<b>Office Action Summary</b>	<b>Application No.</b> 10/767,537	<b>Applicant(s)</b> SMITH, GREG	
	<b>Examiner</b> Hung X. Dang	<b>Art Unit</b> 2873

### **Claims Rejection Under 35 USC - 102**

**FIG. 2**

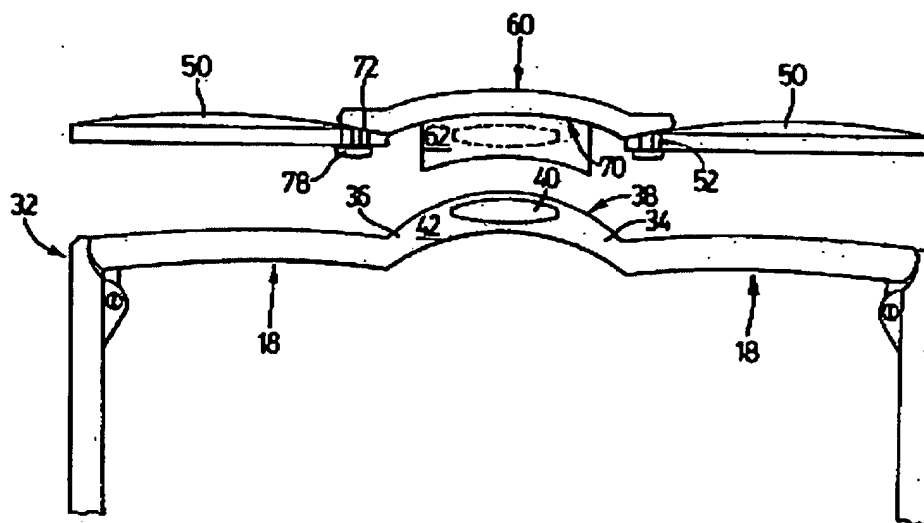
Applicant argued that Ng does not teach the radiused end 38 of the flange 36 being locatable in the interior radius 70 of the clip in complimentary fit of their respective cross-sectional perimeters.

As show in figure 2 and column 4, lines 34-41 above, the radiused end 38 of the flange 36 being locatable in the interior radius 70 of the clip in a tight fit (complimentary fit) of their respective cross-sectional perimeters. Therefore, the claimed invention does not distinguish over the Ng (6,474,810).
